Yuba Community College District

New Softball Field

ADDENDUM NO. 1

Thursday, June 29, 2023

Client Project Number:	Client Proj.
Scale:	Sheet
Drawn By: Author	C5.2
Checked By: Checker	
Issue Date: Issue Date	
Revit Version: 2023	Sheet of _____

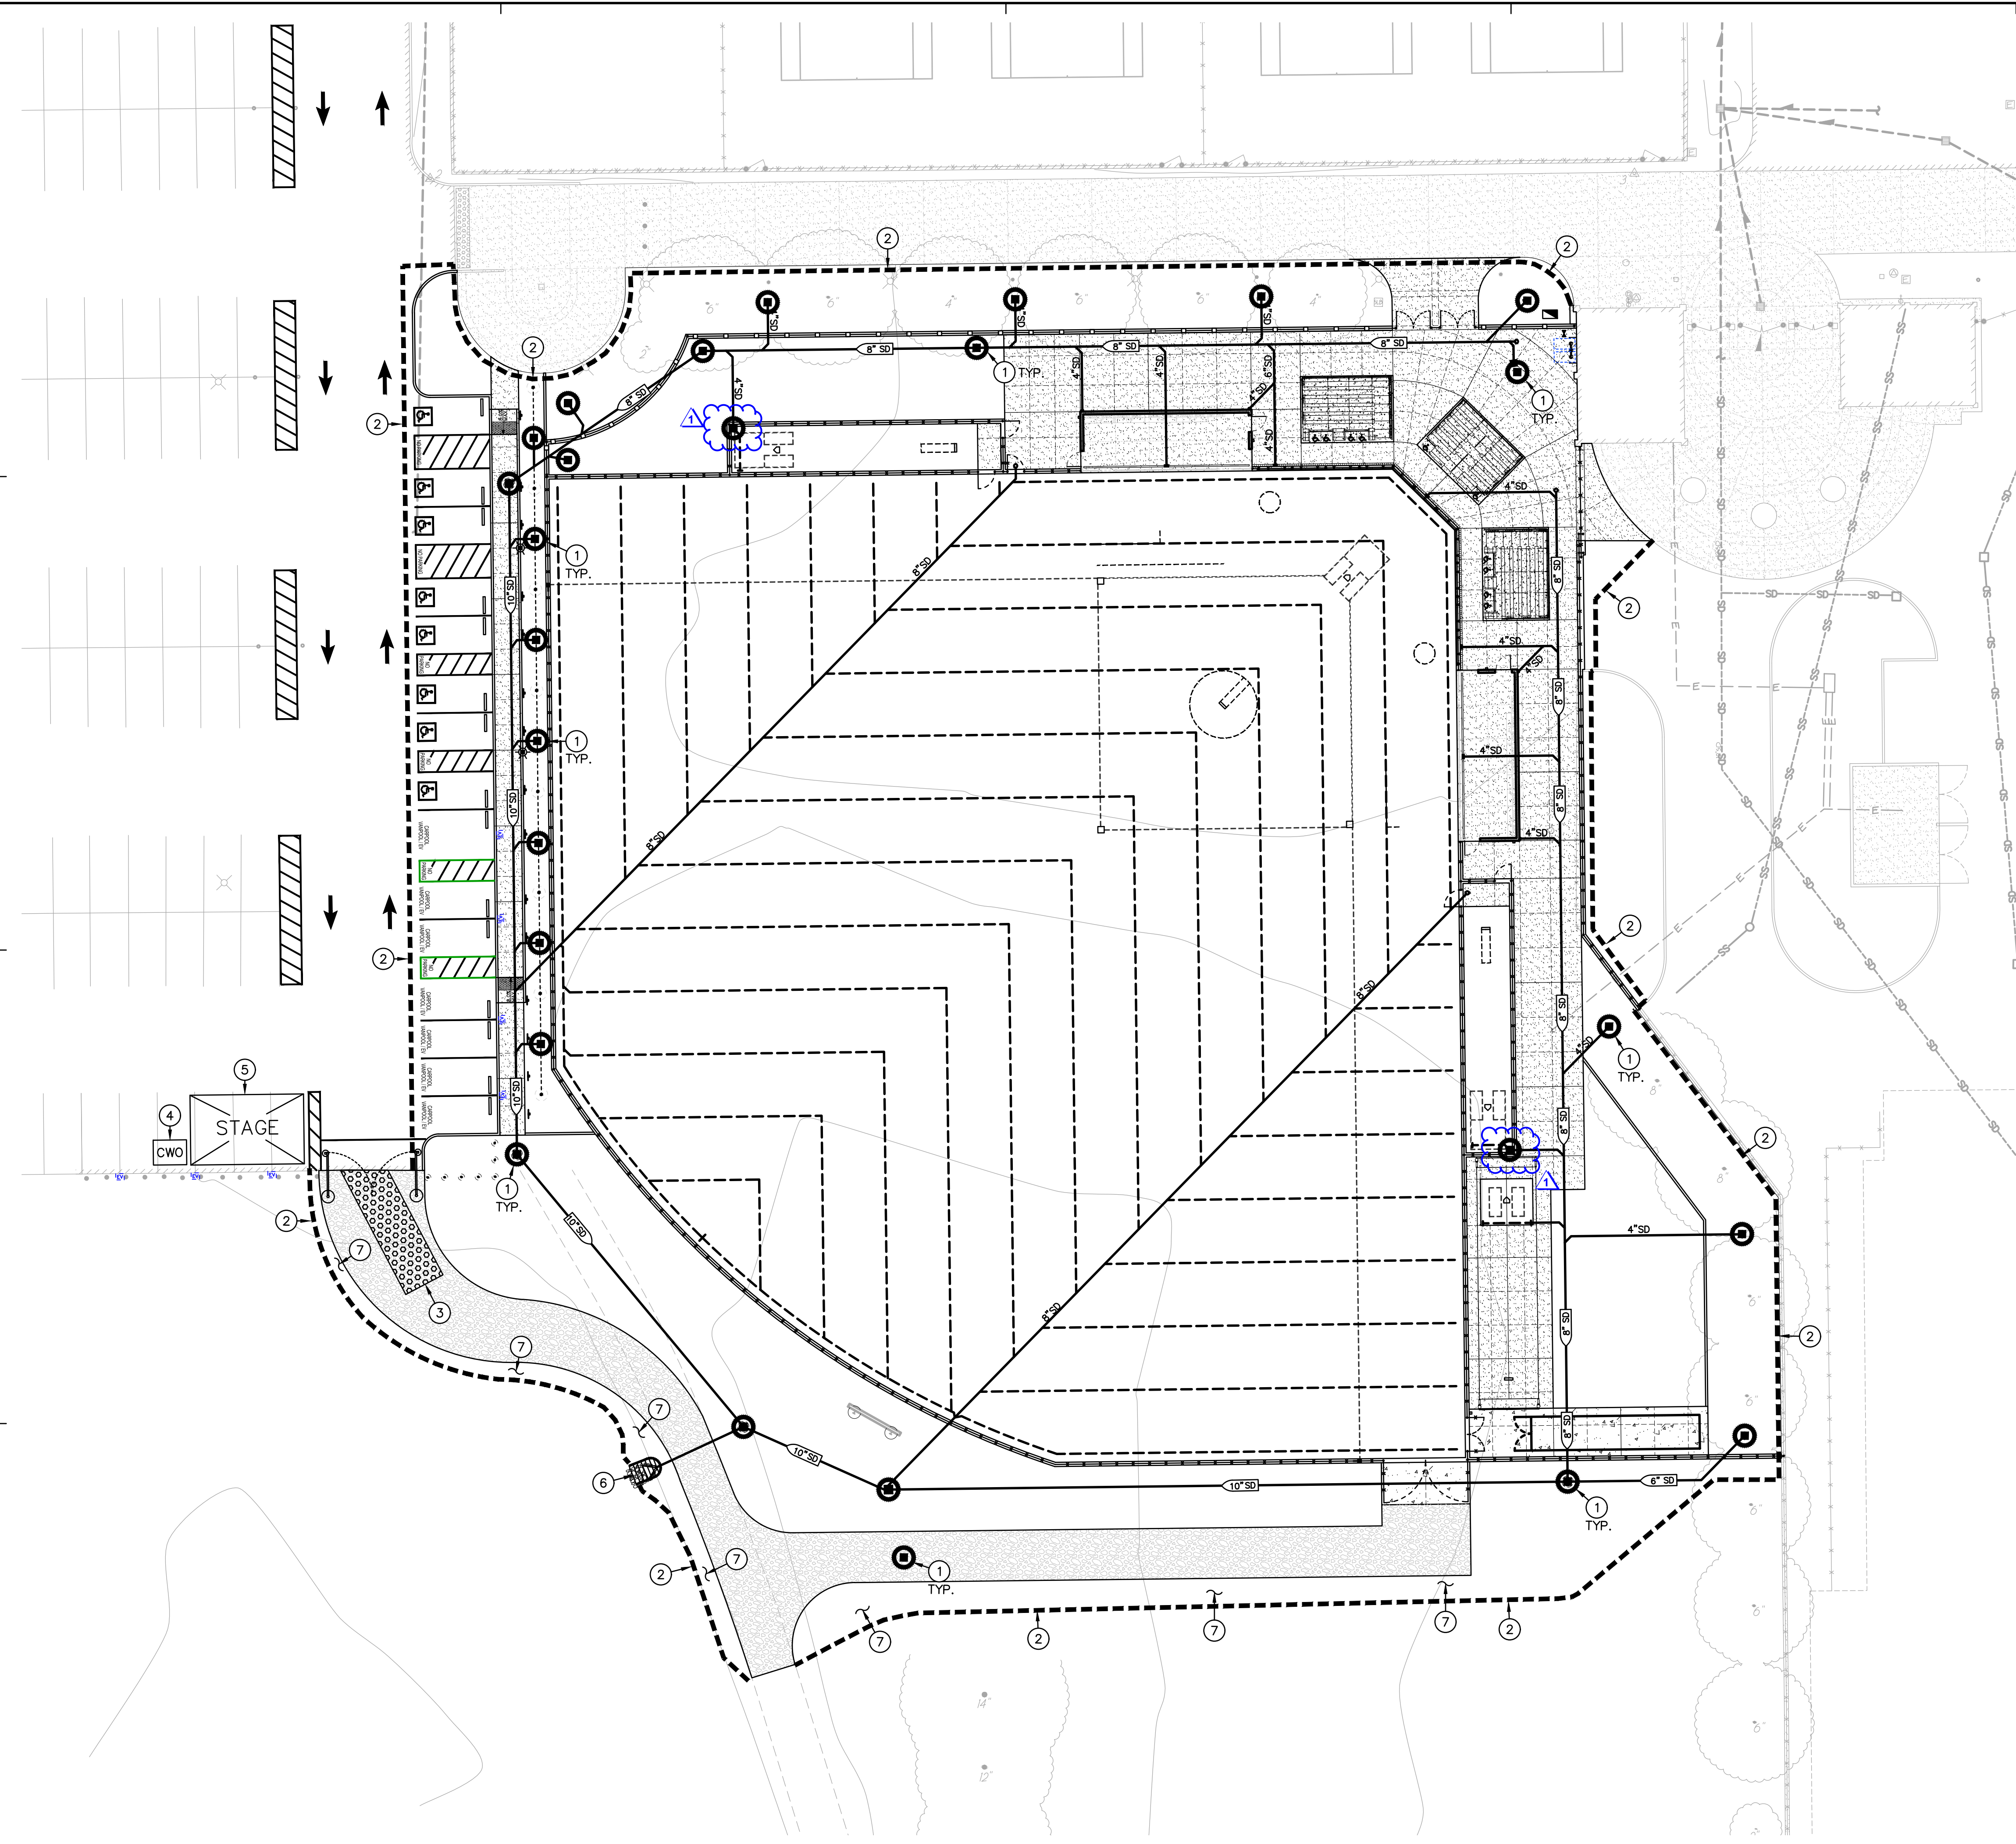
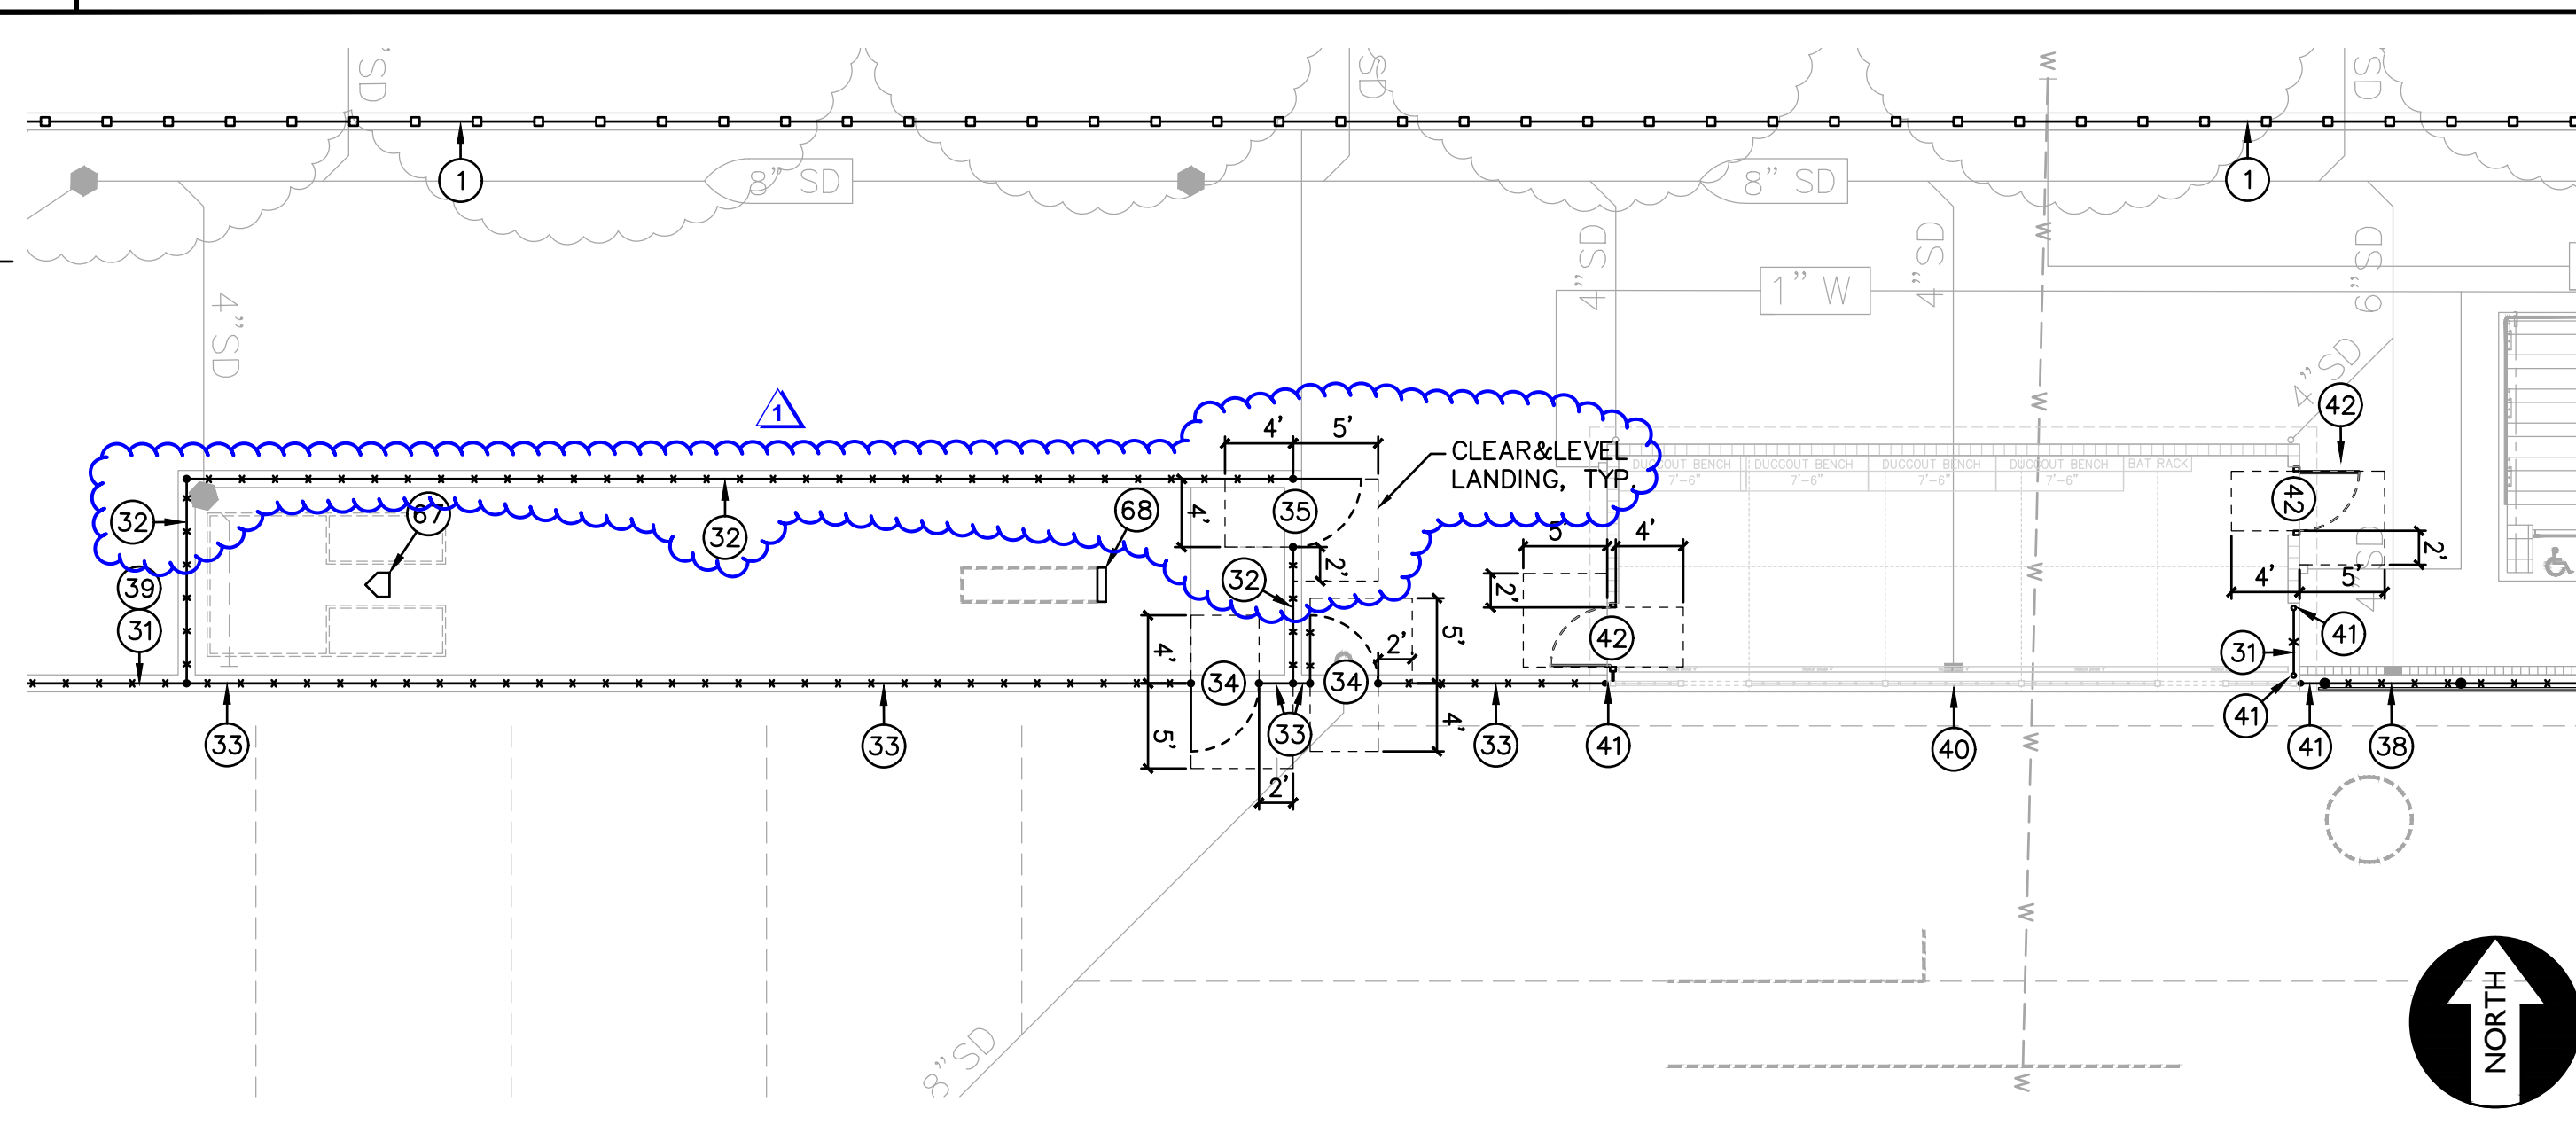
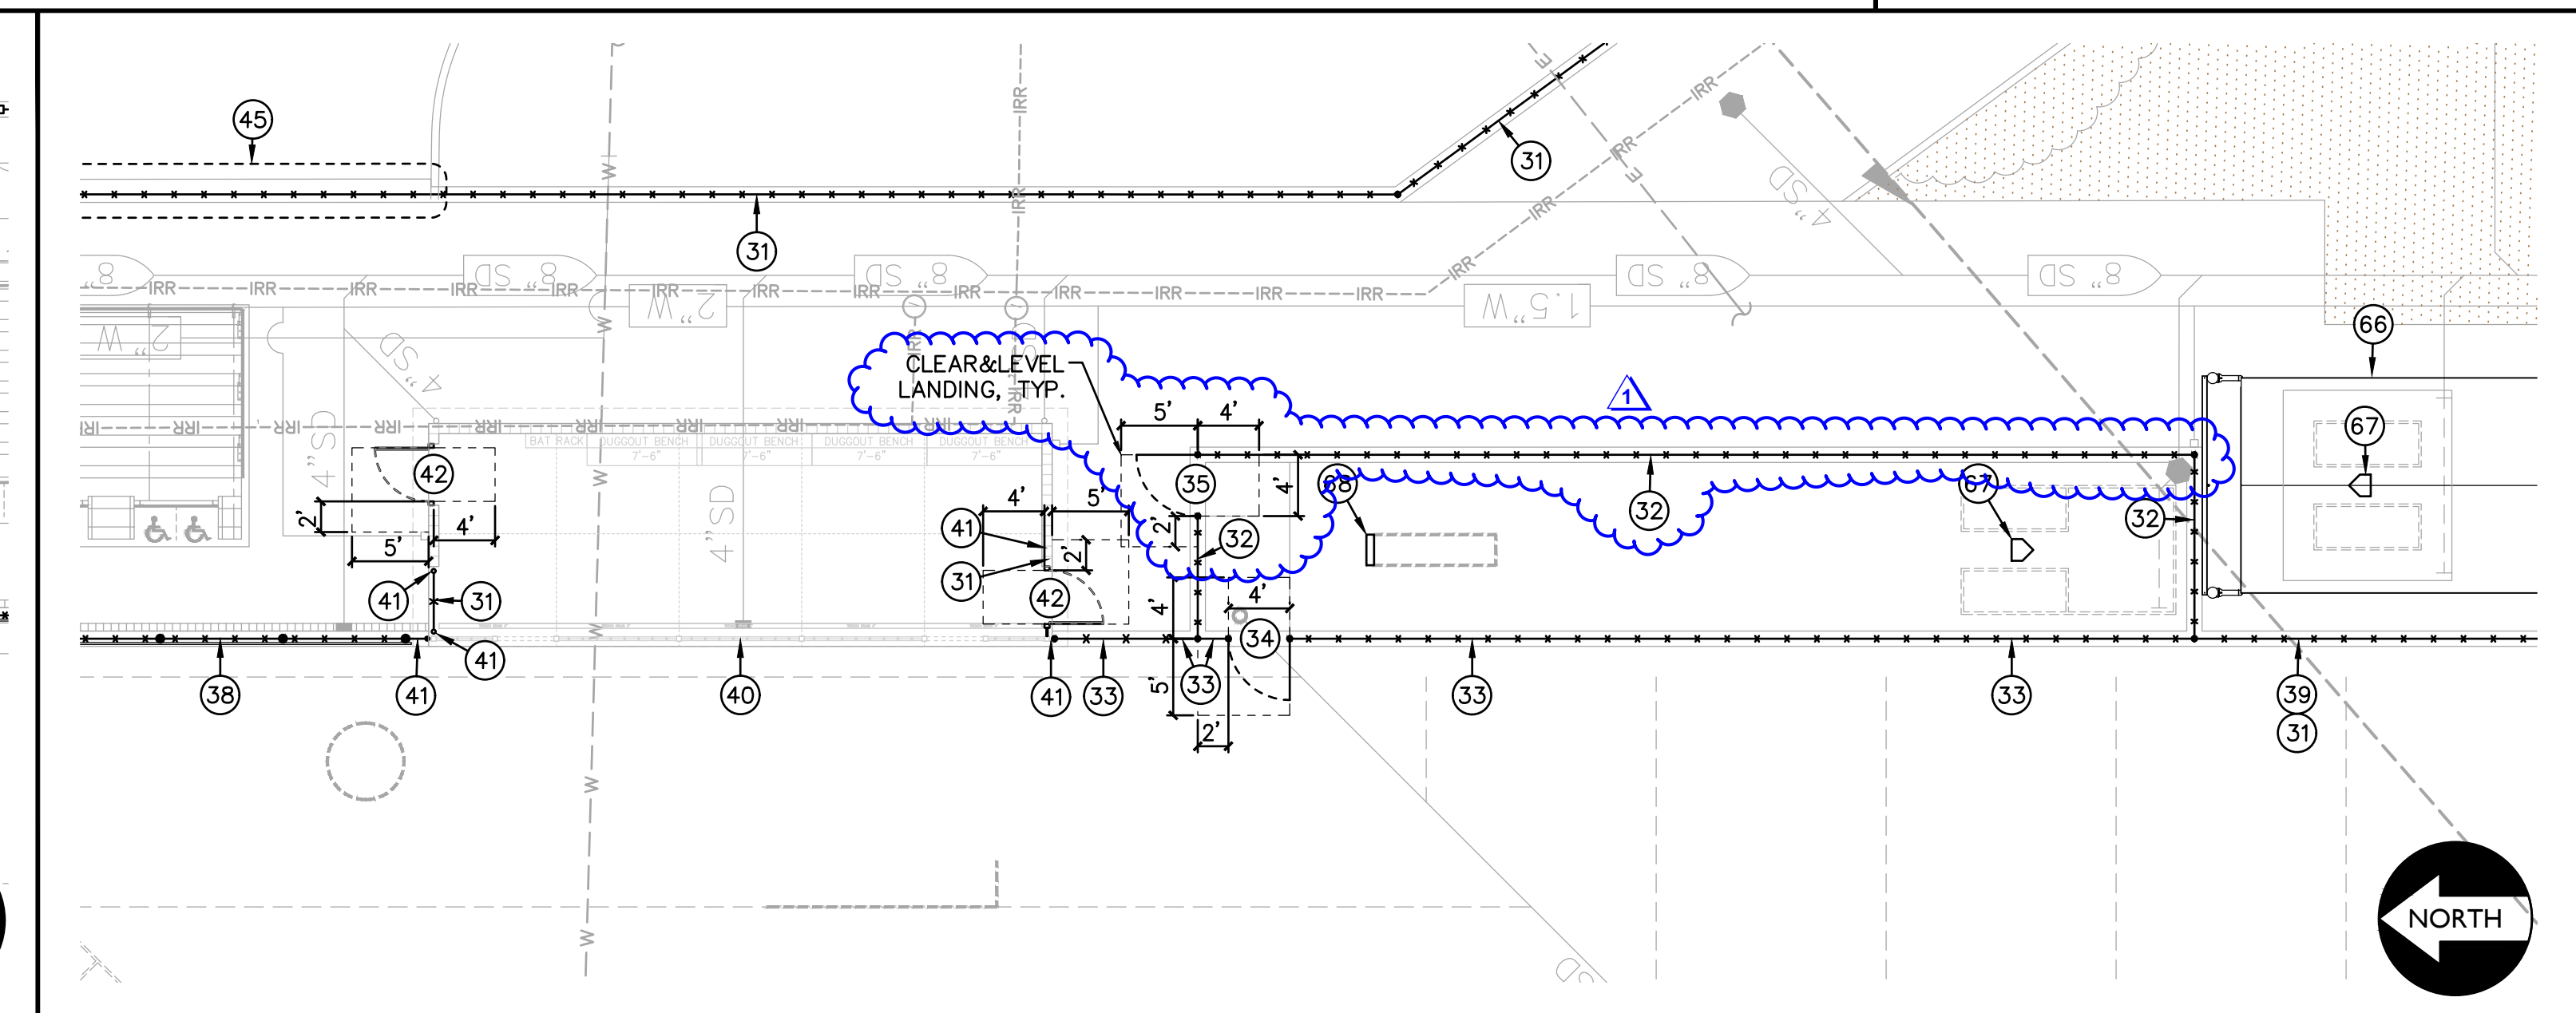
- A. **REVISE** Home and Visitors bullpen from dual to single pitching lanes.
- B. **REVISE** fencing and gate limits at both bullpens. See view 'A' and detail views '1' and '2'.
- C. **REVISE** keyed note 65 to reflect reduction of netting system height from 30' to 20'.
